[Docket No. 2003-NE-52-AD Amendment 39-13410; AD 2003-24-12R1]

Airworthiness Directives; Pratt & Whitney JT9D-3A, -7, -7A, -7F, -7H, -7AH, and -7J Turbofan Engines

2003-24-12R1 Pratt & Whitney:

Amendment 39-13410. Docket No. 2003-NE-52-AD. Revises AD 2003-24-12, Amendment 39-13381.

Figure 1

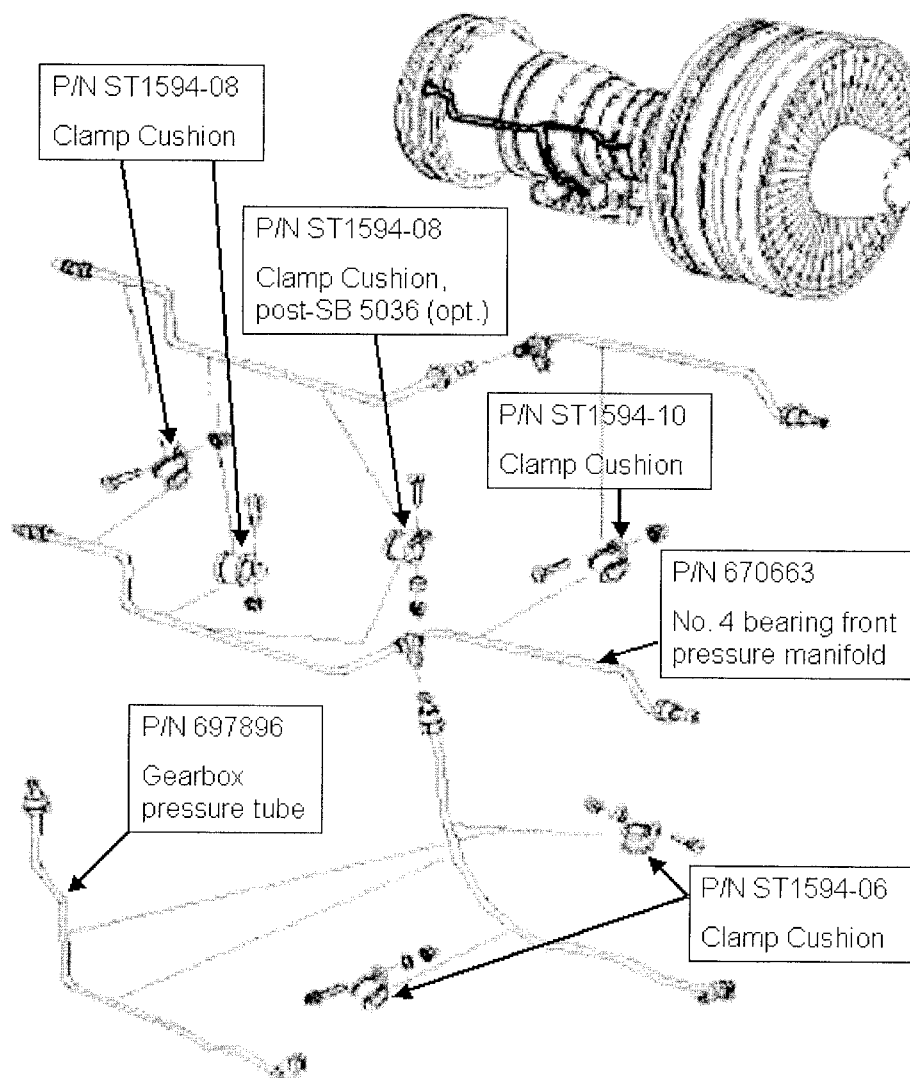
Since that AD was issued, errors in the depicted clamping configuration have been found. The clamping configuration must be correct to ensure that AD compliance can be achieved. Also, an operator has requested that as an option to inspecting dented tubing by passing a ball bearing through the tube, to add dent depth limit criteria for each specific part number tube. The manufacturer supports this optional method and we have added it to the AD. This method avoids having to disconnect the tube from the engine.

(d) This AD results from the need to correct errors in depicted clamping, to ensure that AD compliance can be achieved. The actions specified in this AD are intended to prevent engine fires caused by failed gearbox pressure tubes or failed No. 4 bearing front pressure manifolds.

(f) Visually inspect the clamp assemblies, P/Ns ST1594-06, ST1594-08, and ST1594-10, (see Figure 1 of this AD) that attach the gearbox pressure tube and the No. 4 bearing front pressure manifold to the engine. Replace clamp assemblies before further flight that are rejected by any of the following rejection criteria:

(g) If one or more clamp assemblies are rejected as described in paragraph (f) of this AD, or out of position or missing (see Figure 1 of this AD), clean any debris and oil from the outer surface of the gearbox pressure tube and No. 4 bearing front pressure manifold and visually inspect the tube and manifold. Repair or replace the affected tube or manifold before further flight if it is rejected by any of the following rejection criteria:

(h) Ensure that the gearbox pressure tube, No. 4 bearing front pressure manifold, and clamp assemblies are properly positioned, before further flight, as shown in Figure 1 of this AD.

(1) Cracks, wear, or distortion in clamp metal.

(2) Clamp cushions that are worn, compacted, cracked, coming apart in chunks, deteriorated, or missing. A reddish powder found around the clamp is an indication of deterioration.
